SIB 54 13 19

2020-08-11

FRONT ROLLER SUNSHADE LOOSE

This Service Information Bulletin (Revision 1) replaces SI B54 13 19 **dated November 2019**.

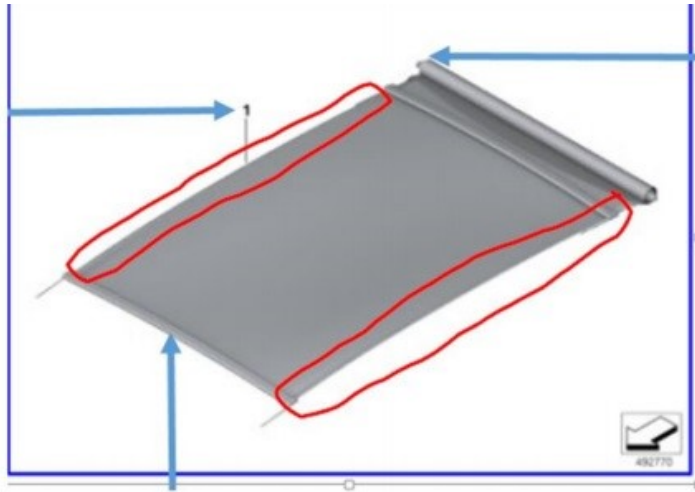
5. Remove the roller sunshade, following repair instructions **REP 54 13 548 “Replacing roller sunblind”**.

With the aid of a second person, hold the sunshade material tight against the reel so that it cannot unwind. Insert a 6 mm hex socket into the end of the sunshade. Remove the locking pin. **DO NOT ALLOW THE SHADE TO UNWIND.**

Turn the reel of the sunshade clockwise 5 complete revolutions as shown below.

Continue to hold the sunshade material tight enough so that it can't unwind. After 5 revolutions, insert the locking pin.

This will add additional spring tension to the roller sunshade.
